RS-06-126

LaSalle County Station, Units 1 and 2
Facility Operating License Nos. NPF-11 and NPF-18
NRC Docket Nos. 50-373 and 50-374

Subject: Additional Information Supporting the License Amendment Request
Associated With Direct Current Electrical Power

Enclosure (1): Temp. Correction for Float Current at Various Voltage Settings Graph

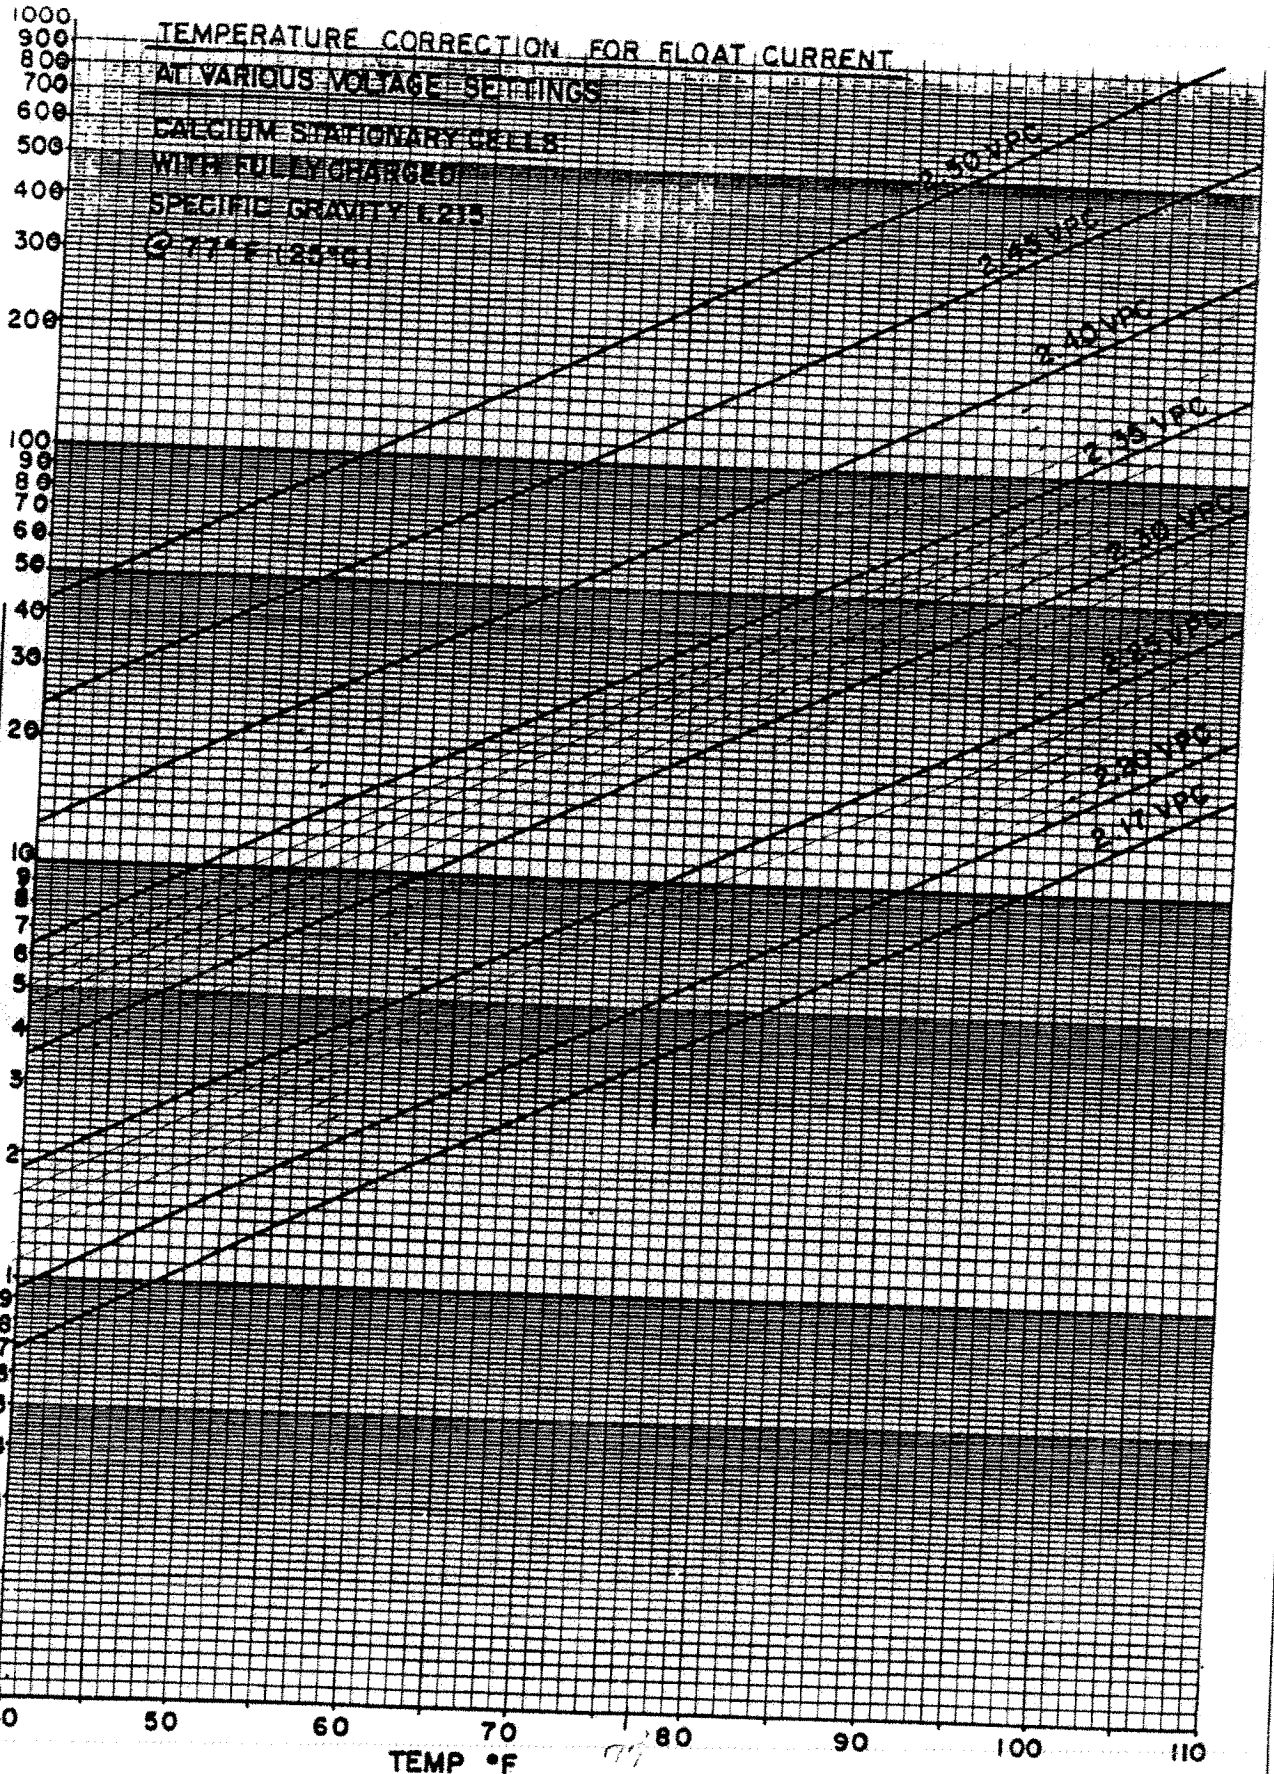
Per your e-mail request for float current for both NCN-17 and NCN-27 at 100% charge and 95% charge. Attached is a graph which shows current vs. temperature. The provided graph represents the average of the entire line of lead-calcium cells.

In accordance with the manufactures Instruction and Operation Manual, the Float Charge for Lead Calcium Cells with 1.215 specific gravity electrolyte is 2.17 to 2.25 volts per cell (VPC). Both the NCN-17 and NCN-27 cells fall into this category. Requiring that the current be less than 1 amp when the cells are 100% fully charged ensures that the float current is enveloped on the graph, regardless of temperature.

The cells should be approximately 95% charged following an equalize charge. Using the manufactures recommended equalizing voltages (2.24 to 2.39 VPC), we can show on the graph that a requirement of 2 amps envelops the float current for all temperatures below 89°F. At 2.33 VPC the 2-amp requirement envelops the float current for all temperatures below 105°F.
